# Technical Service Bulletin

<b>Topic</b>	DTC P096C00 and / or P096F00 evident within the Engine Control Module
<b>Market area</b>	Bentley: worldwide (2WBE),China 796 VW Import Comp. Ltd (Vico), Beijing (6796)
<b>Brand</b>	Bentley
<b>Transaction No.</b>	2075941/3
<b>Level</b>	EH
<b>Status</b>	Released for publishing
<b>Release date</b>	Dec 10, 2025

Figure 4

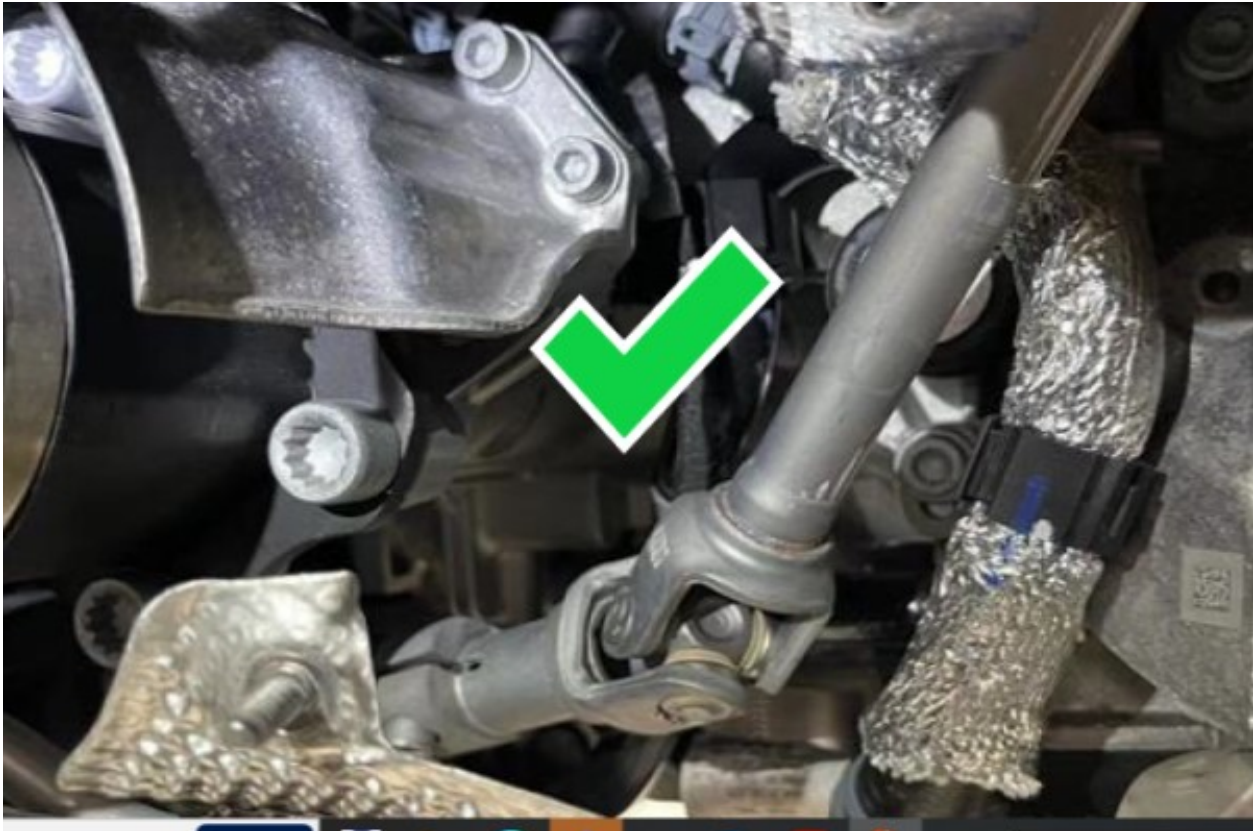
4) Secure the harness as shown in Figure 4

Ensure the wiring harness is secured / clipped to a solid location DO NOT SECURE THE HARNESS TO ANY MOVING COMPONENTS OR COOLANT HOSES
